West Wallsend Colliery

Submission made by: Adrian Trevor – Manager of Electrical Engineering

On behalf of: West Wallsend Colliery (WWC)

The draft Work Health and Safety (Mines) Regulation 2014 (herein referenced as the draft), has, in areas attempted to move towards a balanced approach, however, still contains areas of prescription that are excessive. The specific areas have been addressed in the submission below.

Figure 1 - NSW WHS Legislative Framework - Mines

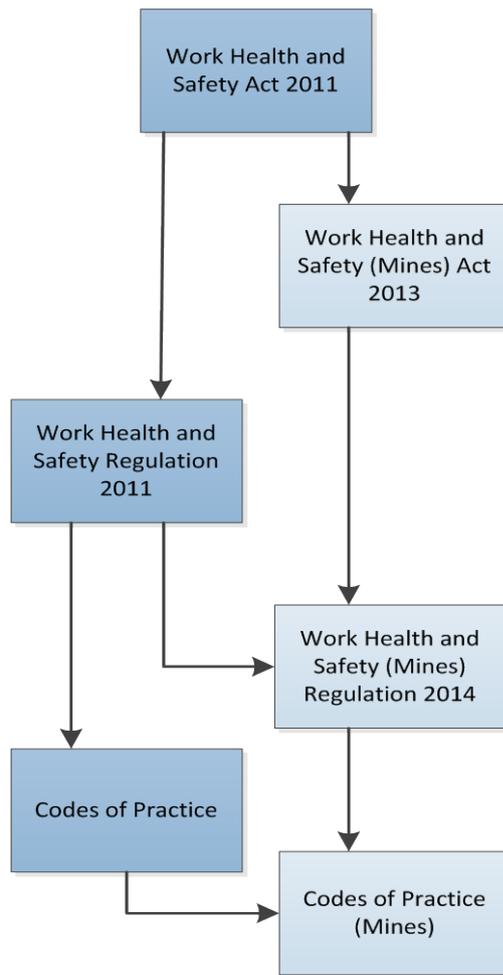
We have found that the diagram detailing the framework of WHS legislation in the Discussion Paper for the draft regulation (page 13) is not consistent with clause 4 in both the WHS (Mines) Act 2013 and the draft regulation. We have interpreted from these clauses that a more accurate representation of the framework would be that set out below in Figure 2.

We have also interpreted from the WHS regulation that in the case of any inconsistency between this regulation and the draft mines regulation that the WHS Regulation prevails (*Refer Work Health and Safety Regulation 2011 – Clause 14 Inconsistencies between provisions - If a provision of any document applied, adopted or incorporated by, or referred to in, this Regulation is inconsistent with any provision in this Regulation, the provision of this Regulation prevails*).

Action: Confirmation is required regarding the above representation of the framework and the interpretation regarding inconsistencies is accurate.
